# Staff Report

To: Salt Lake City Planning Commission  
From: Doug Dansie, Senior Planner, [doug.dansie@slcgov.com](mailto:doug.dansie@slcgov.com) or 801-535-6182  
Date: August 14, 2019  
Re: Central Station Apartments - Planned Development and Design Review (PLNSUB2019-00477 & PLNPCM2019-00399)

## Planned Development & Design Review

Sheet Title  
 Overall Floor Plan Level 2

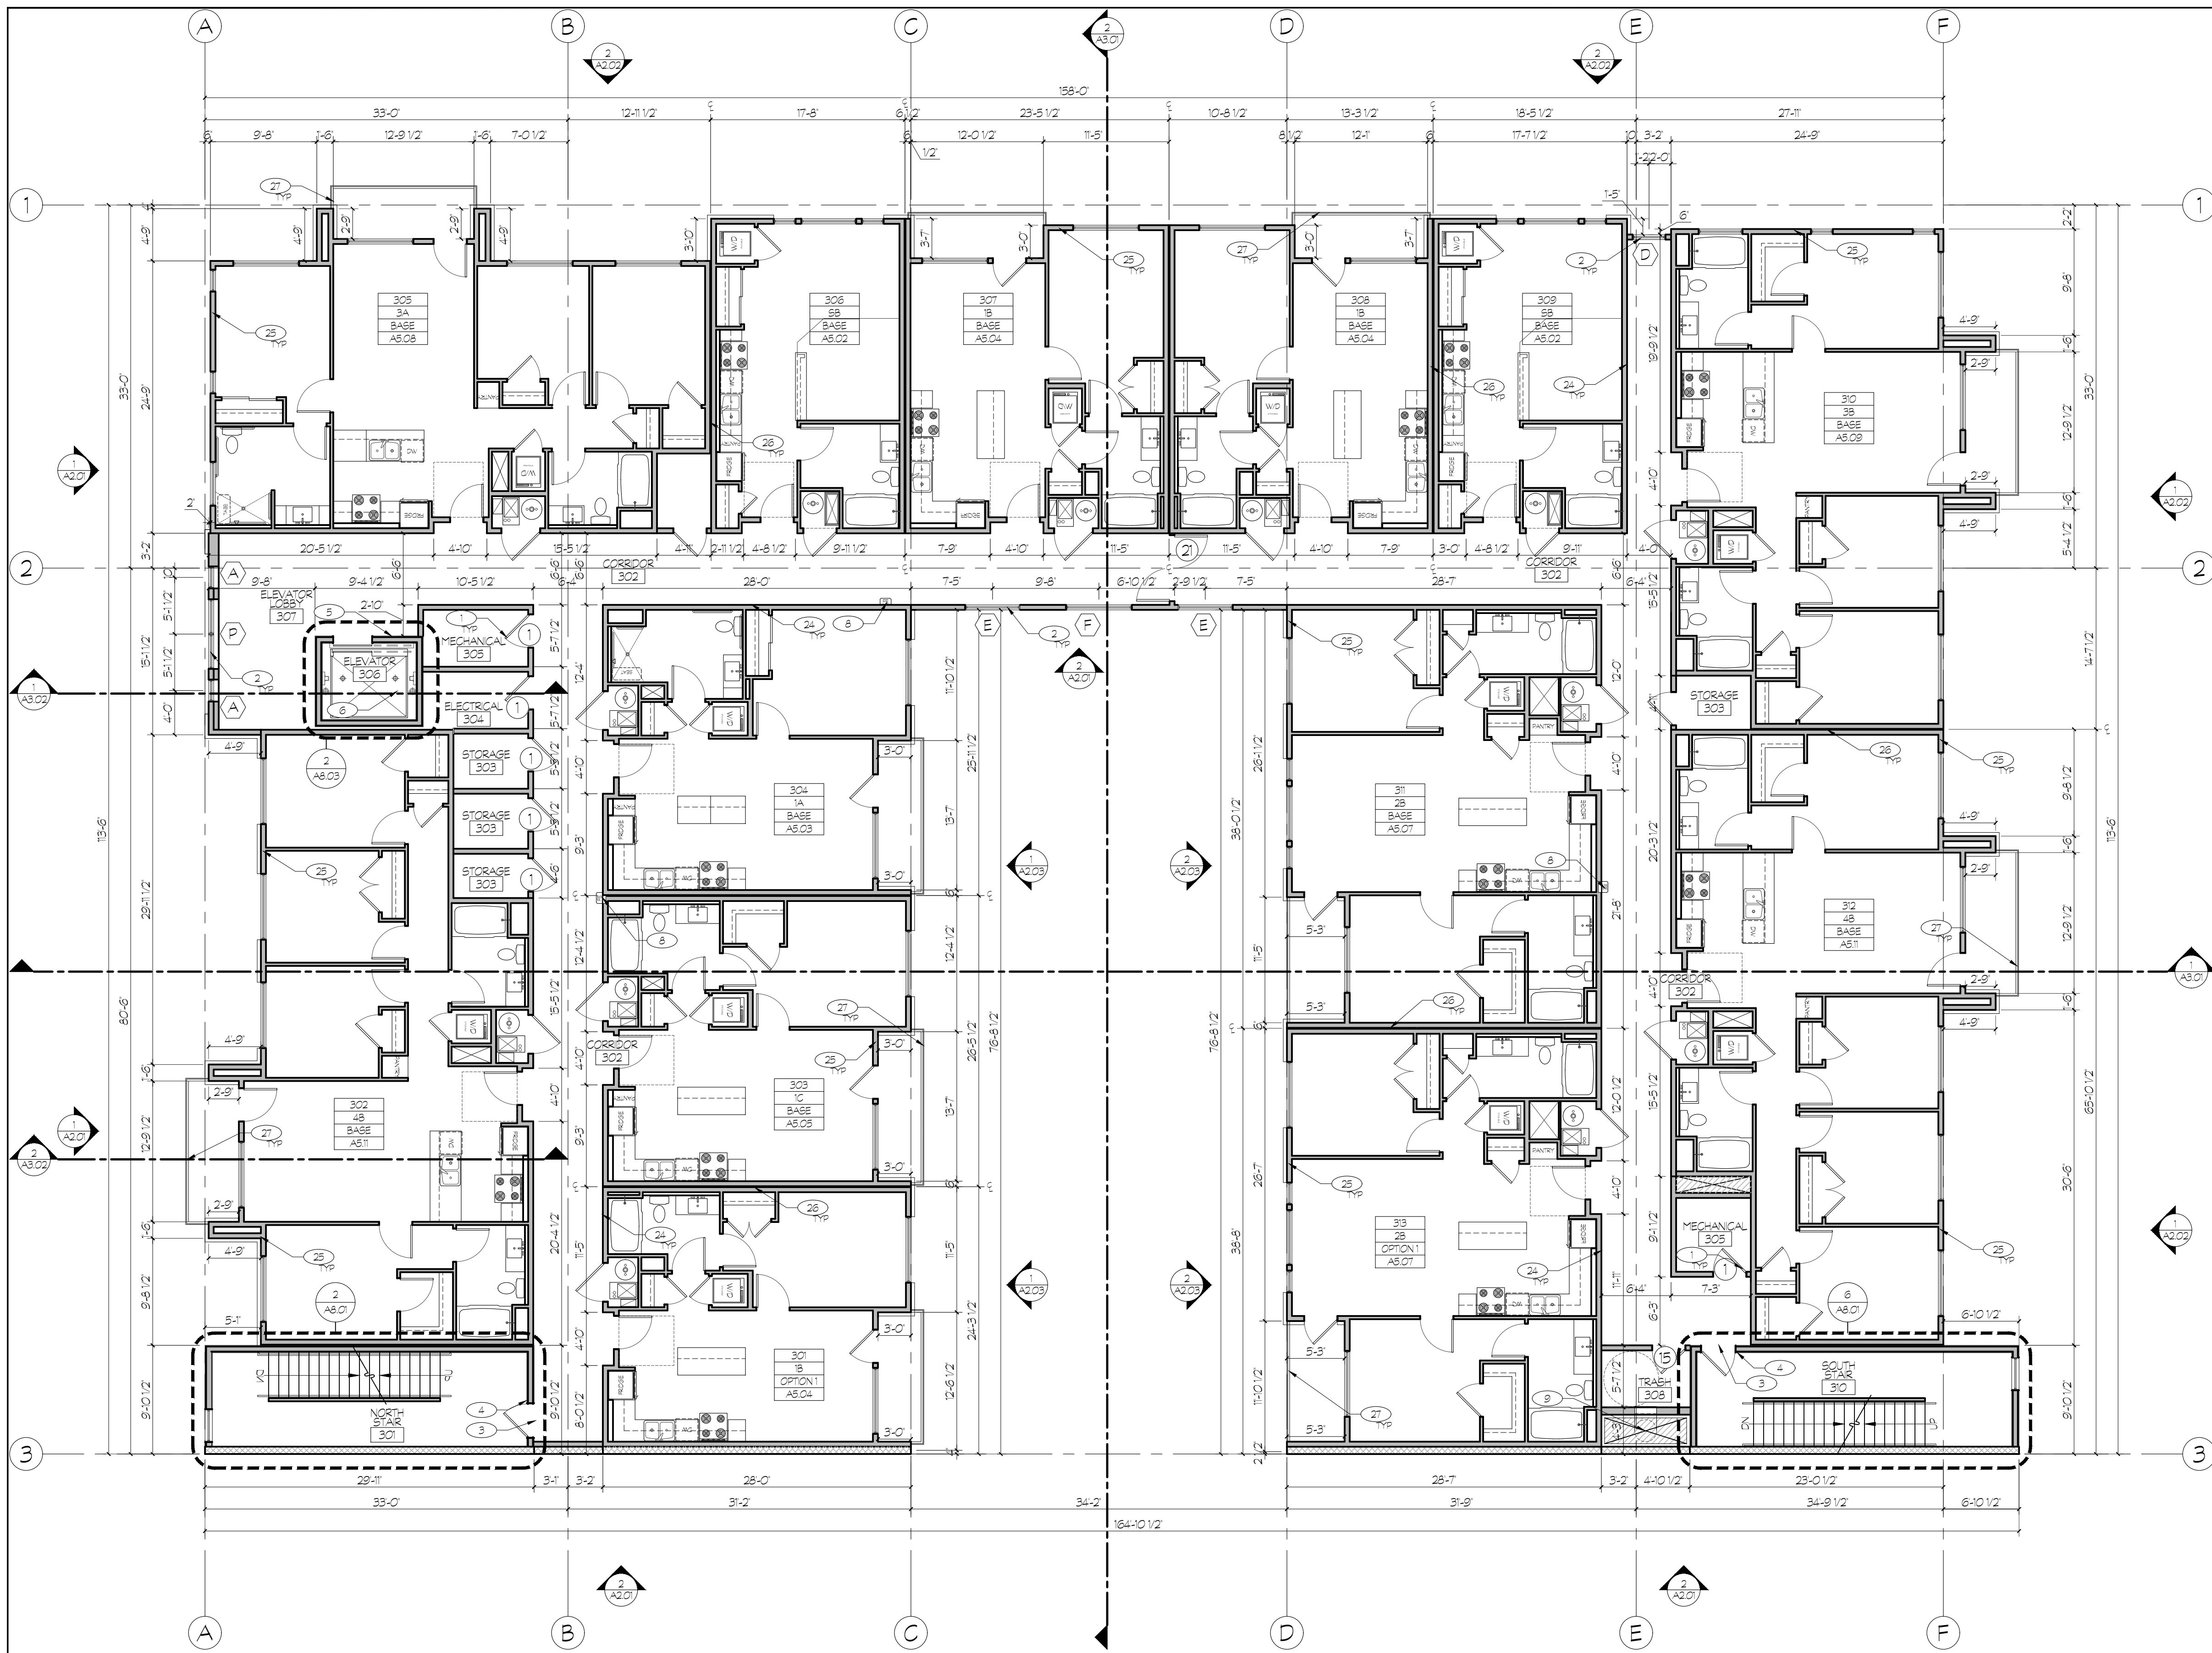
- A1.02 thru A1.08 show projections over, or right up to the property line on the North, South, and East. Projections are not allowed per IBC 705.2 less than 2 feet from property line. Note – Woodbine Street to the East is not a public way. This is a private street on an adjacent parcel.

- A1.01 thru A1.07 show openings on the property line on the East. Openings are not allowed per IBC 705.8 less than 3 feet from property line. Note – Woodbine Street to the East is not a public way. This is a private street on an adjacent parcel.

- Sheet F1.04, A1.03. The courtyard has only one exit. With having only one exit, it is required to have an occupant load of 49 or less and a maximum common path of egress travel distance of 75 feet per IBC 1006.2.1. This space does not demonstrate an occupant load of 49 or less or meet the maximum common path of egress travel distance for a space with only one exit.
